Subject: Site Visit of May 10-13, 1983
Midland Plant Underpinning Contract

REPORT OF SITE VISIT
May 10-13, 1983

MIDLAND PLANT UNDERPINNING

SITE VISIT REPORT
MIDLAND PLANT, UNITS 1 AND 2 (50-329/330)
DATE OF SITE VISIT: MAY 11 AND 12, 1983

FIG. 1

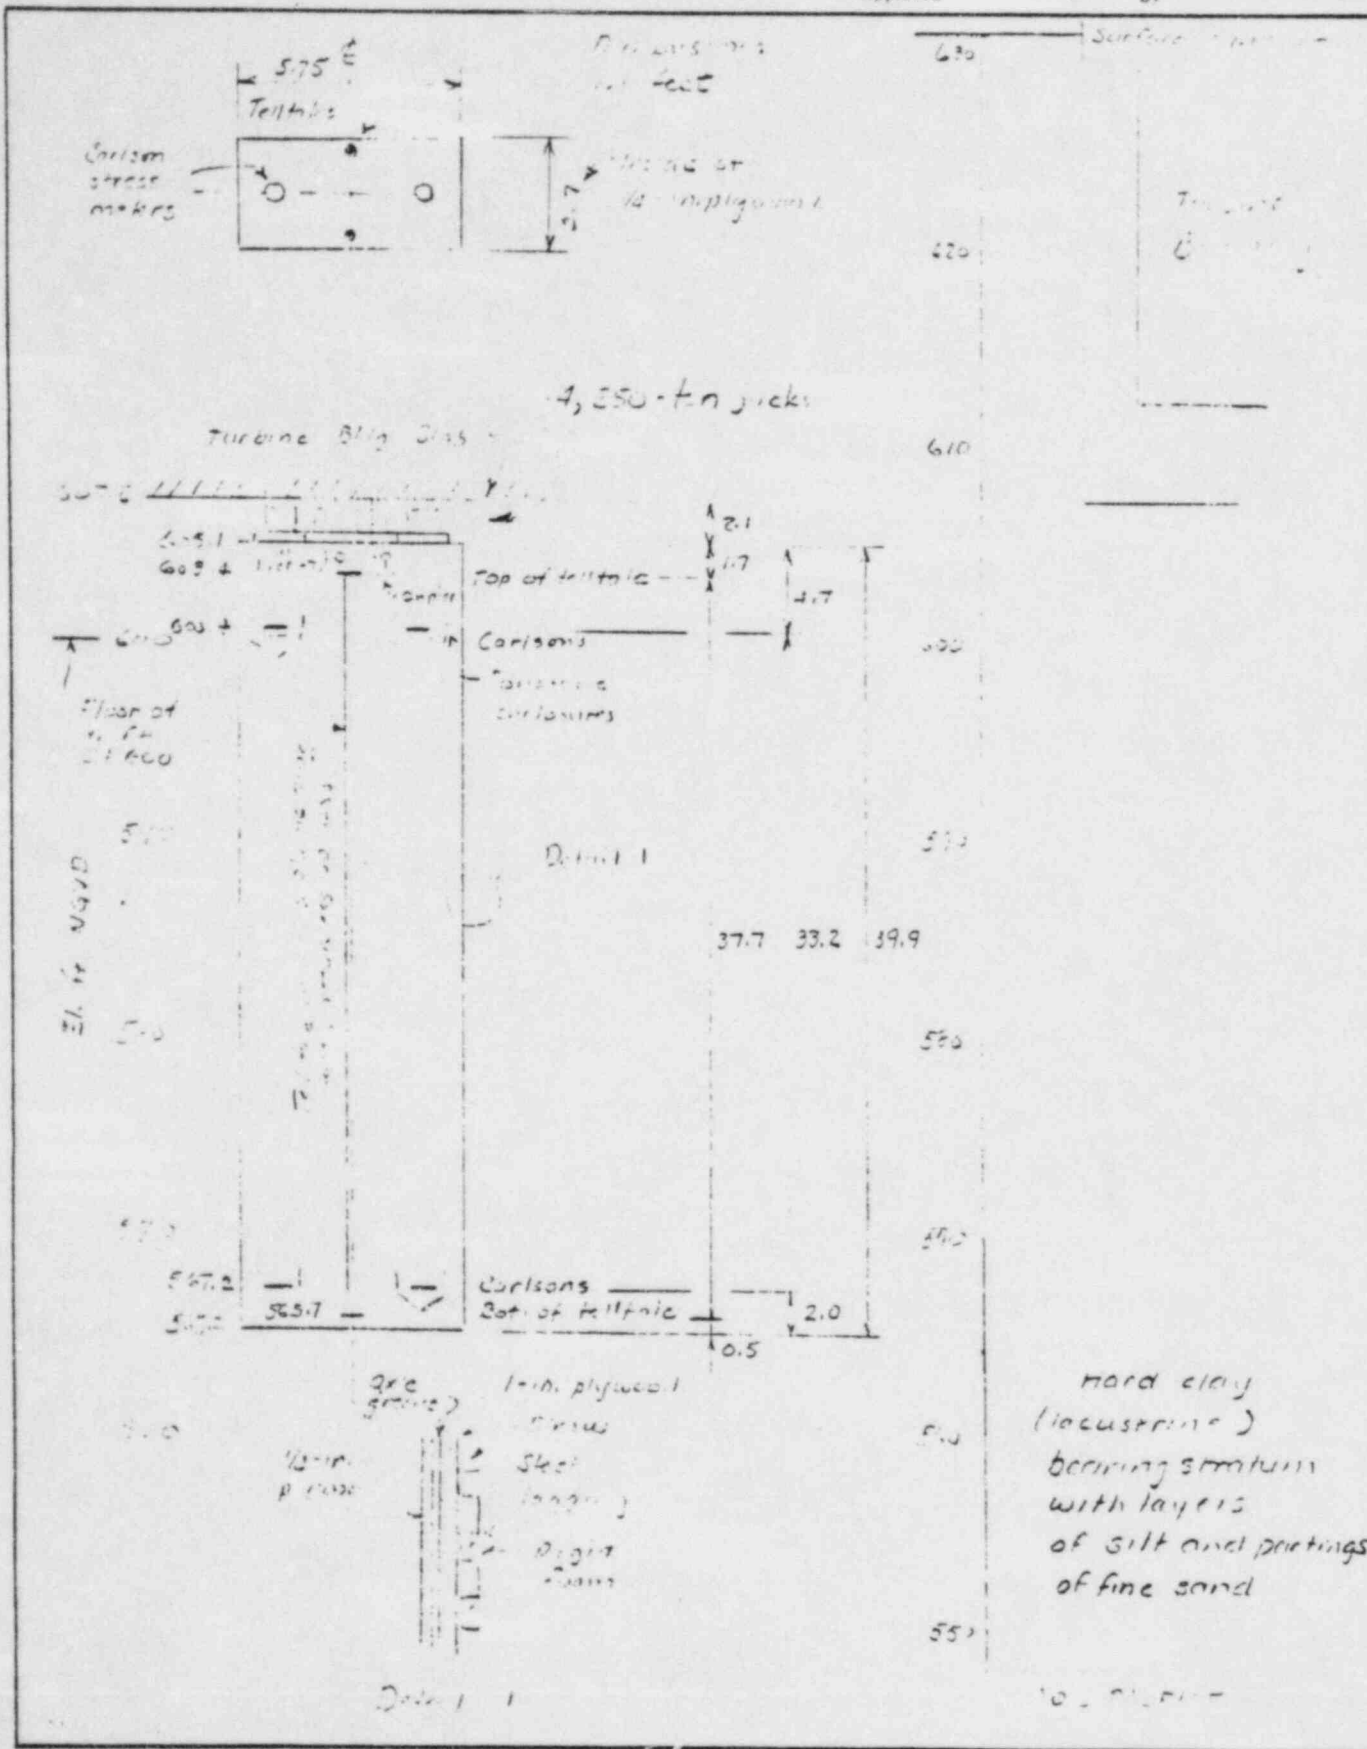
A concrete pier shown in Fig. 1 was tested to 600 kips. The sides of the pier were greased to reduce skin friction. However, the data indicated that substantial side friction developed. Perhaps only two thirds of the 600-kip load reached the bearing stratum. As a result, considerable uncertainty remains about the equivalent modulus of elasticity of the soil, E_s , based on the data.

FIG 2

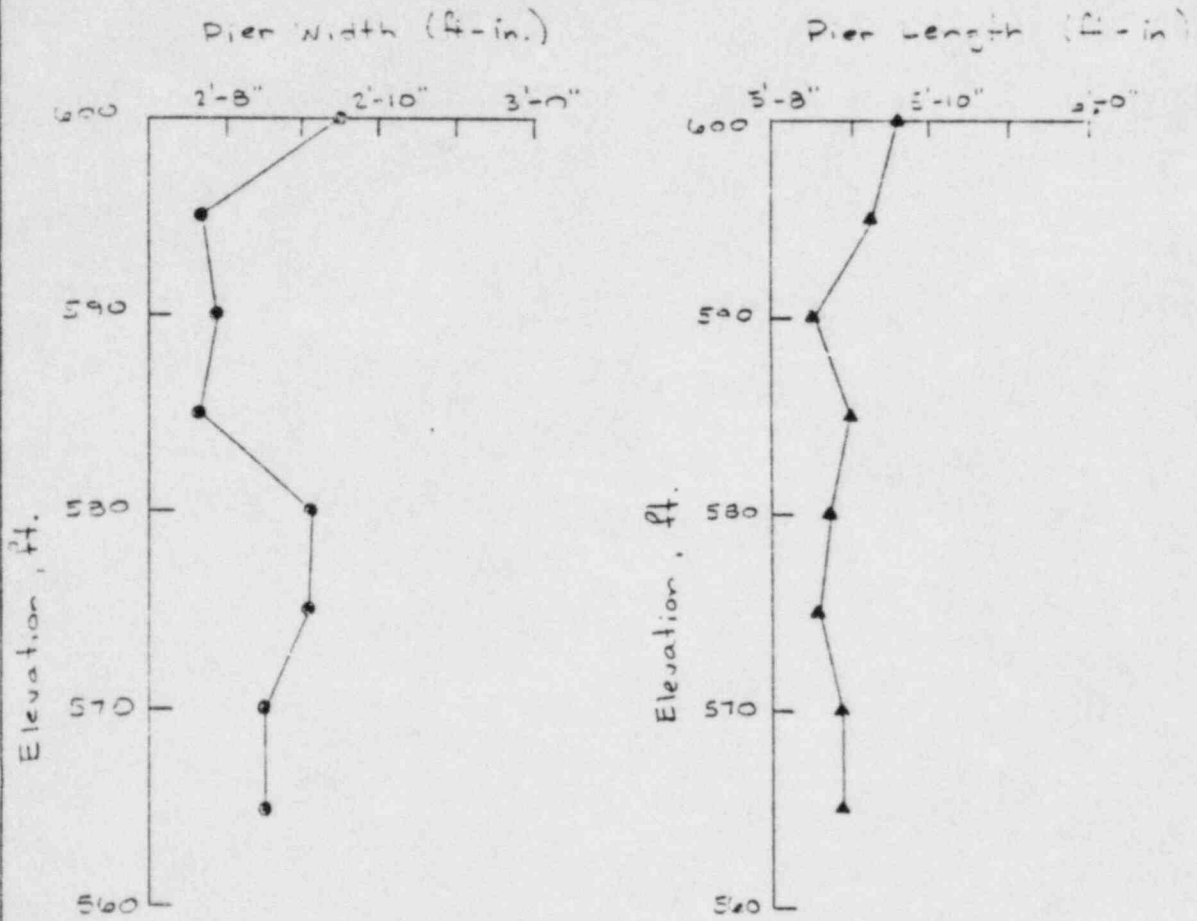
The friction probably developed due to the shape of the sides of the pier shaft, which varied ± 0.5 in. over its height, as shown in Fig. 2.

FIG. 3

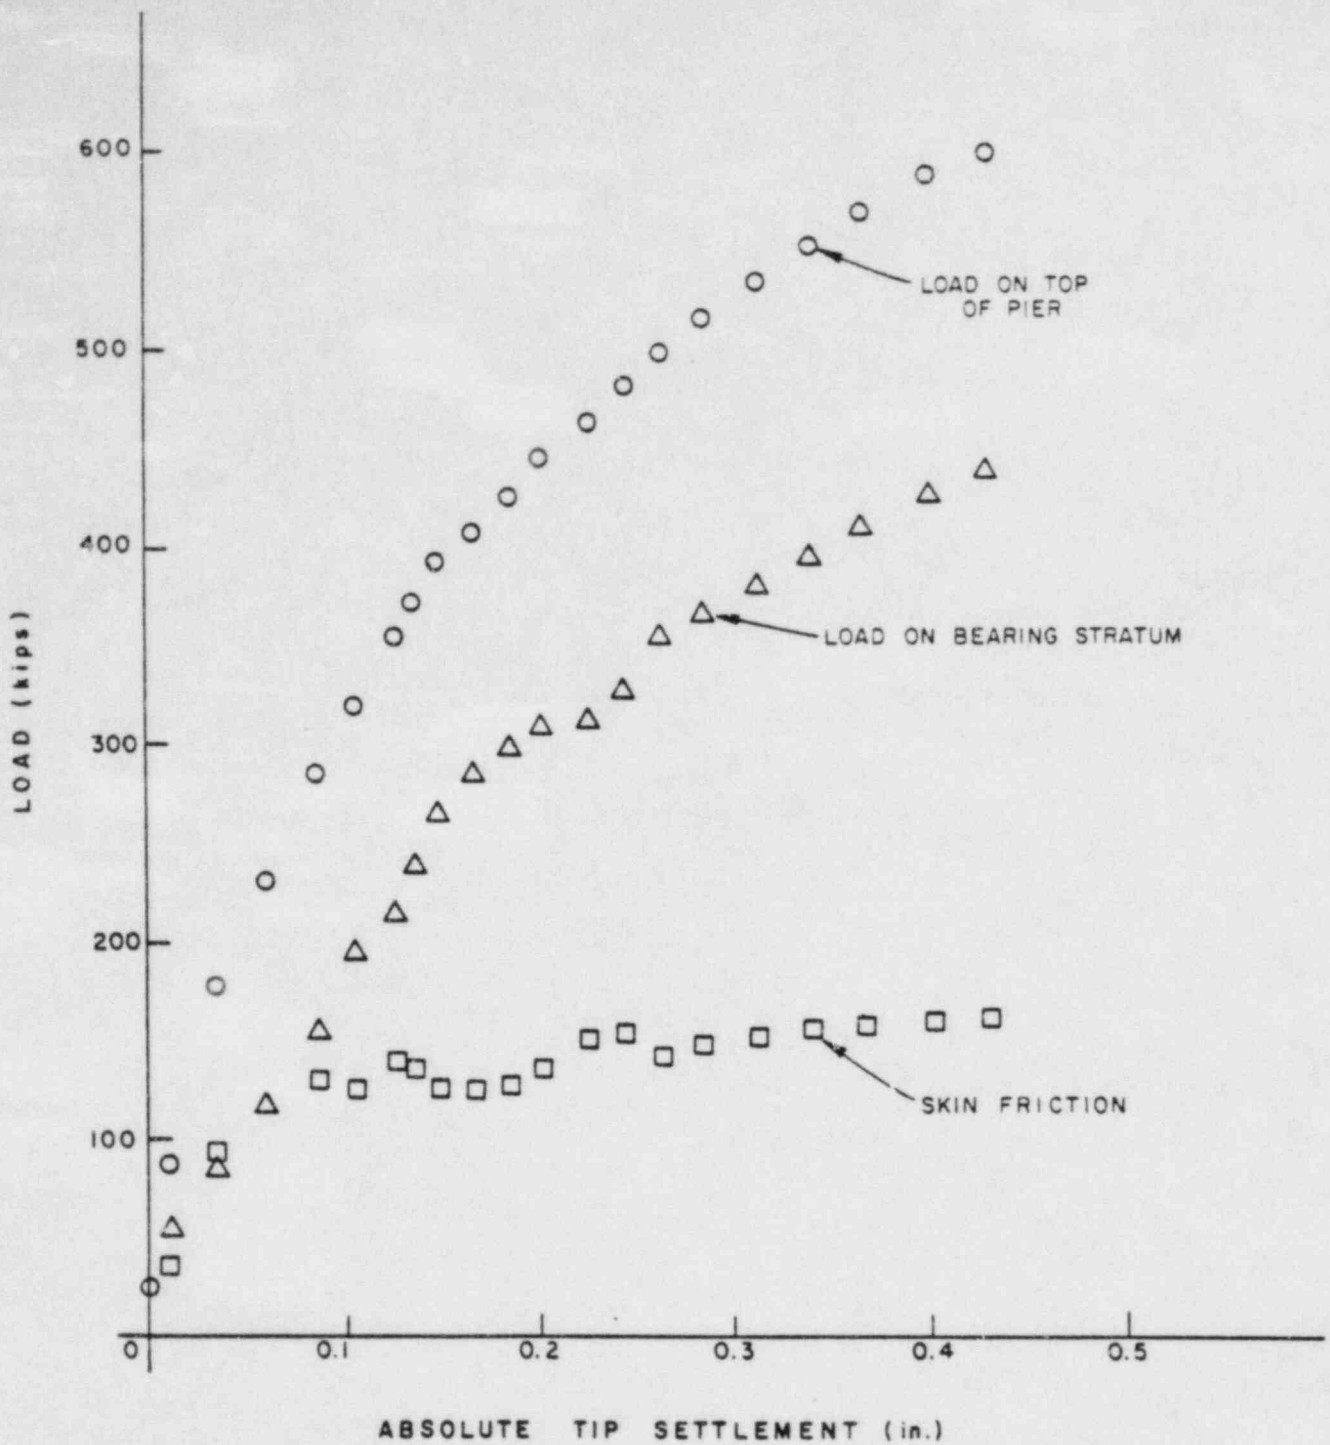
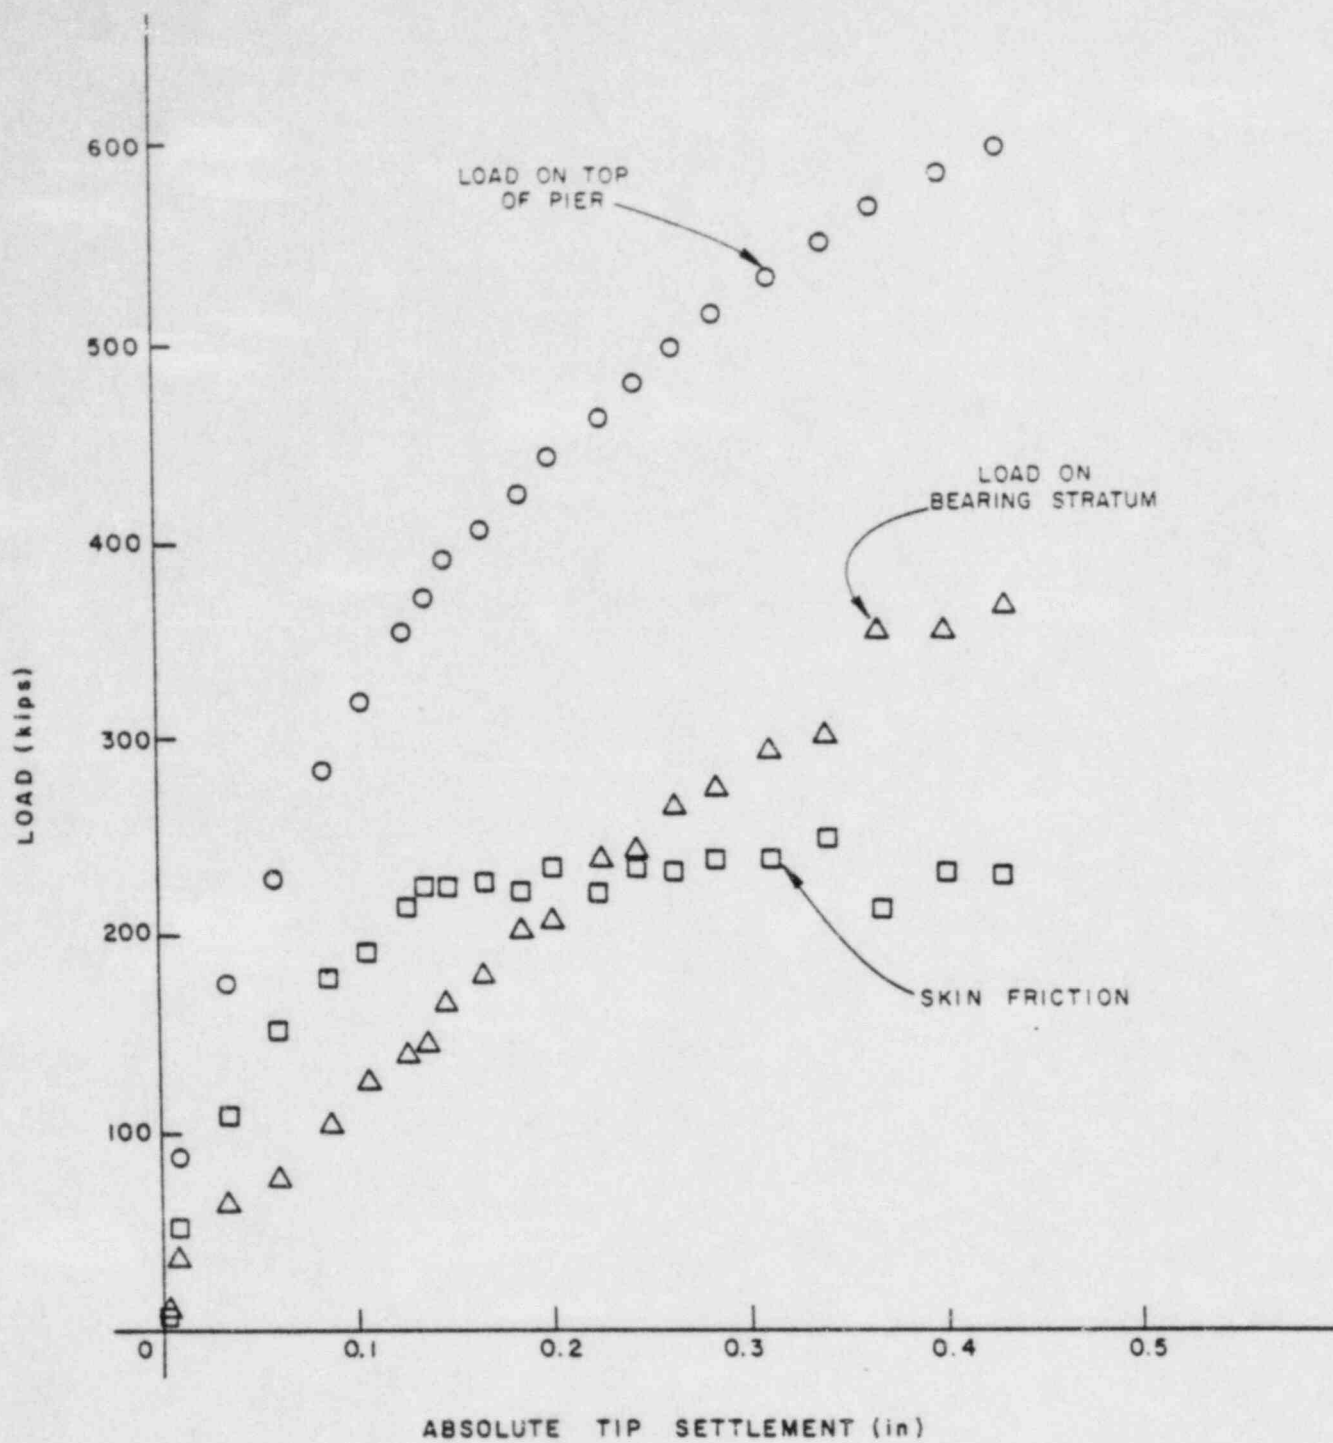
Modulus of Hard Clay - The pier compression data and the Carlson stress meter data permit independent estimation of the side friction. Figs. 3 and 4 show the load at the top vs tip settlement, the estimated skin friction, and the estimated tip load vs tip settlement based on the analyses provided during our site visit. From Figs. 3 and 4, the following modulus values are obtained at various stress levels:

Basis	Bearing Stress ksf	Equivalent Modulus, E_s , ksf		
		Surface	At Depth (Mindlin)	Average
Carlson Meters (Fig. 3)	8.8 13.0	2800 2680	1540 1470	2170 2080
Pier Compression (Fig. 4)	8.8 13.0	1620 1600	890 880	1260 1240

The Mindlin solution for stresses within an elastic mass indicates that the above modulus should be multiplied by 0.55 to account for the depth effect. However, this solution over-corrects for real soils because it is based on the assumption that tensile stresses above the pier bottom restrain settlements. Real soils do not support tensile stresses. The average of the value of E_s at the surface and at depth is used in the table above in the absence of (1) a more rigorous analysis, (2) knowledge of the distribution of skin friction on the pier, and (3) knowledge of the properties of the fill at this location.

FIG. 5

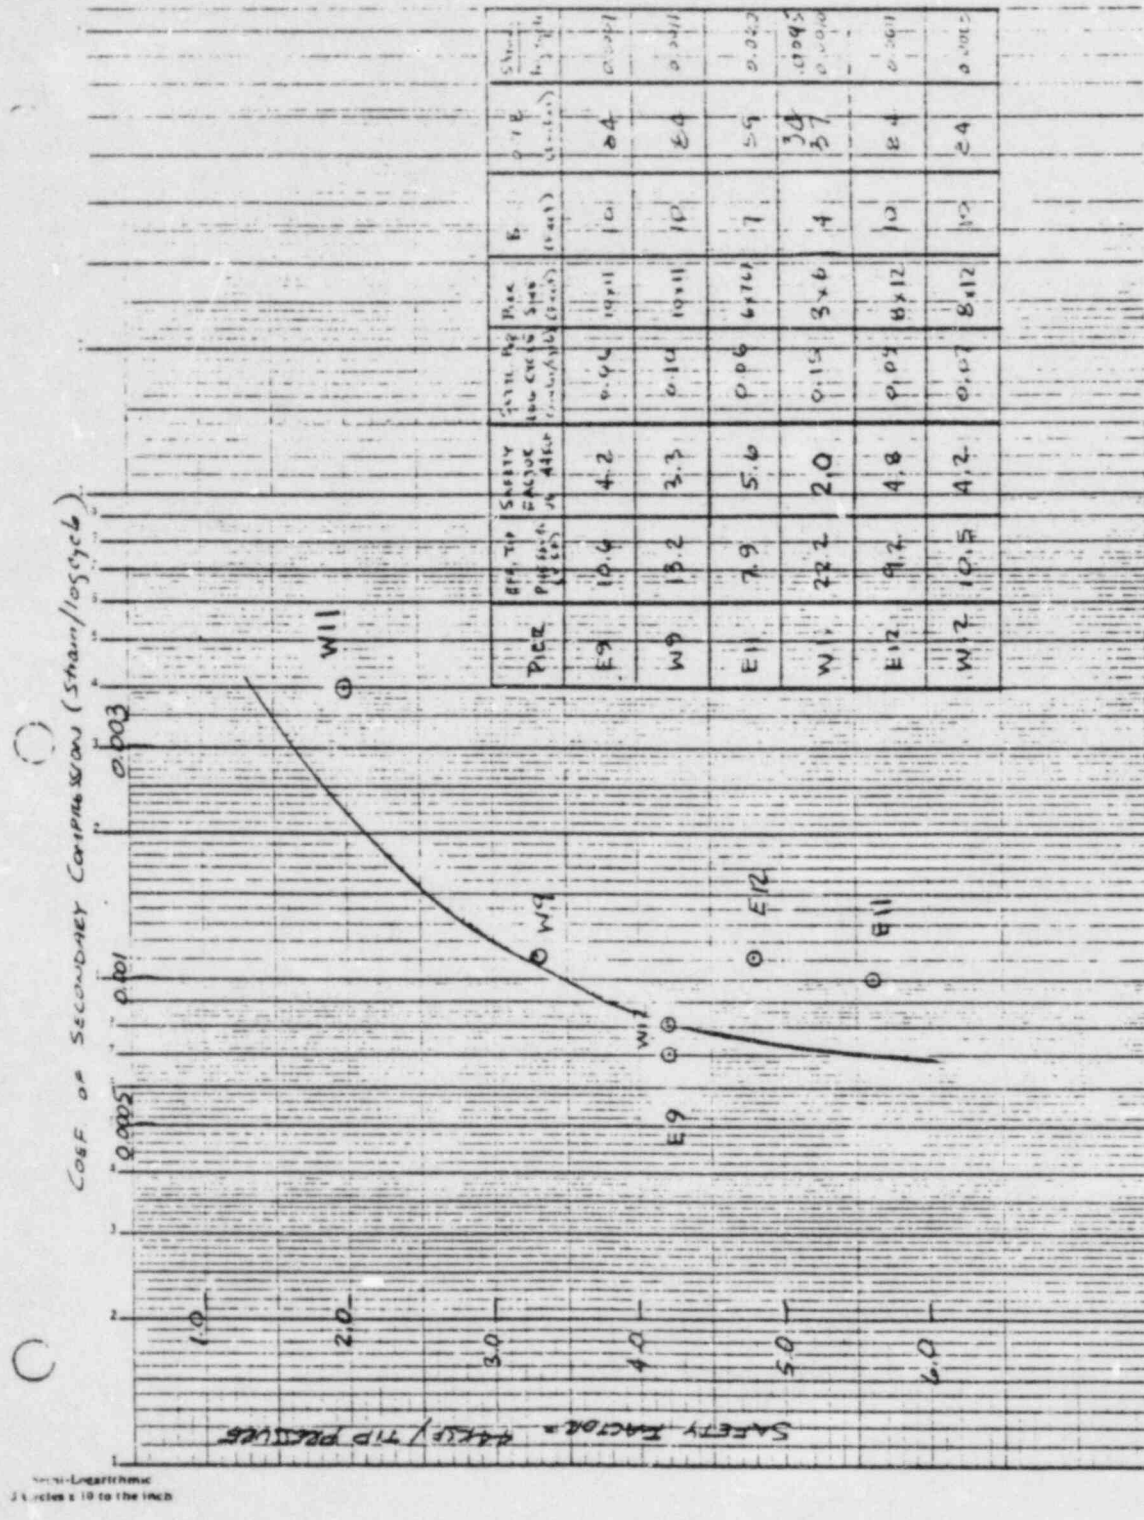
Secondary Compression of Hard Clay - Fig. 5, provided at the site visit, shows the apparent secondary compression in the test pier (W11) for a top load of 600 kips. The rate of secondary compression is impeded by skin friction. It is not known what the value would be in the absence of skin friction. However, the bearing pressure at the tip is considerably larger than the design pressures. Therefore, the rate of secondary settlement for the completed foundation can be expected to be smaller than shown for Pier W11.

The rate of secondary compression measured in all piers ranged over values that are greater than those anticipated in design. The lower end of the measured range is at the

upper end of the anticipated range at the design bearing pressures. For the completed foundation the group action of the piers will reduce the effect of skin friction on the rate of secondary compression. We would anticipate higher rates of secondary compression, perhaps by a factor of two, on average, than were used for design.

The important parameter with respect to design is the differential settlement between the underpinned foundation and the auxiliary building. Thus, the actual secondary settlement in inches/log cycle of time must be estimated before the loads are permanently transferred to the underpinning. Extrapolation of such data will provide the required estimate of differential settlement.
